# UNITED STATES PATENT AND TRADEMARK OFFICE

APPLICATION NO.	FILING DATE	FIRST NAMED INVENTOR	ATTORNEY DOCKET NO.	CONFIRMATION NO.
10/689,348	10/20/2003	Stephan Grunow	TI-36564	4206
23494 7590 08/21/2008 TEXAS INSTRUMENTS INCORPORATED P O BOX 655474, M/S 3999 DALLAS, TX 75265				
EXAMINER				
MOVVA, AMAR				
ART UNIT		PAPER NUMBER		
2894				
NOTIFICATION DATE		DELIVERY MODE		
08/21/2008		ELECTRONIC

### Office Action Summary

## DETAILED ACTION

*FIG. 2a*

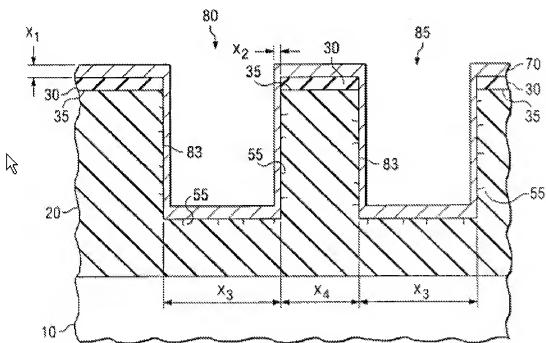
Examiner notes that applicant's independent claims state that the first contiguous barrier layer (70) is formed to thickness X1 over said upper surface (35) of the low K dielectric layer (20) within the trench and X2 on the sidewalls of the trench, wherein the ratio of X1 to X2 is 3:2. The applicable standard for determination of an instance of new matter is that the new claim matter is neither expressly nor inherently disclosed.

Regarding the lack of express disclosure, Applicant's specification discloses a 3:2 ratio vis a vis X1:X2, wherein X1 refers to the barrier layer (70) on the upper surfaces (35) of the low K dielectric outside of the trench (see e.g. fig. 2a reproduced below) and X2 is thickness on the sidewalls of the trench, thus applicant's disclosure only supplies support that the barrier layer is formed to a thickness X1 (ratio 3:2) outside of the trench. While it is possible to, in view of fig. 2a, to find support in applicant's disclosure that a portion of the contiguous barrier layer (70) is thicker in the trench than

on the sidewalls of the trench it is not sufficient to support a claim that the ratio of  $X_1$  to  $X_2$  is 3:2 with  $X_1$  in the trench.

Furthermore the disclosure does not inherently show a 3:2 ratio since issues that would cause the thicker portion of 70 in the trench vis a vis thicker portion outside of the trench to vary (in PVD and CVD as specified in the specification as the methodology of depositing layer 70) would be poor step coverage depending on the specific materials of the deposition, a lack of knowledge as to what angles were used in the deposition, and whether or not the deposition may have had multiple steps with masks to isolate certain areas for deposition.

a. Applicant argues that one of ordinary skill in the art would have easily appreciated that the upper surface of the dielectric layer refers to not only the surface (35, fig. 2a) outside of the trench but also the bottom of the trench. It should be noted that applicant's specification expressly discloses: " XI represents the thickness of the non- conformal layer 70 formed over the **upper surface 35** of the low K dielectric layer 20" (lines 13-15, page 8) which identifies the upper surface as element 35. Surface 35 is identified three times for all the surfaces outside of the trench in fig. 2a. **Most critically neither of the bottoms of either trench labels the surface to be element 35.** Thus in light of applicant's specification one of ordinary skill in the art would conclude that the "upper surface" refers to the surfaces 35 labeled outside of the trench. Moreover the labeling of the upper surface in applicant's specification appears to contravene applicant's current interpretation of what the upper surface comprises.

b. Applicant argues that labeling a thickness of one part of the barrier layer on the upper surface does not preclude other portions of the figure from including that same surface. As a preliminary matter examiner notes that the standard is what one of ordinary skill in the art would understand the reference of an upper surface to be not what may be possible. Specifically Surface 35 is identified

three times for all the surfaces outside of the trench in fig. 2a. **Most critically neither of the bottoms of either trench labels the surface to be element 35.** Thus in light of applicant's specification one of ordinary skill in the art would conclude that the "upper surface" refers to the surfaces 35 labeled outside of the trench.

c. Applicant argues that it would have been redundant to re-label the bottom portion of the trench barrier layer since it is the same as the layer 70 over the barrier 30. Applicant's argument illustrates the lack of an express disclosure of the thickness of the bottom portion of the trench barrier layer. One of ordinary skill in the art would indeed assume that a thickness illustrated in one section of layer is consistent throughout **had the layer been uniform**. However, barrier layer 70 varies in thickness. One of ordinary skill in the art would not read different portions of layer to be both of X1 thickness when an intervening portion of the layer is of a different thickness and thus express labeling of the bottom portion of the trench barrier layer is necessary. Furthermore had said labeling

been redundant, it would beg the question as to why said upper surface labeling (35, fig. 2a) was repeated three times over the surface outside the trench with no corresponding labeling within the trench.
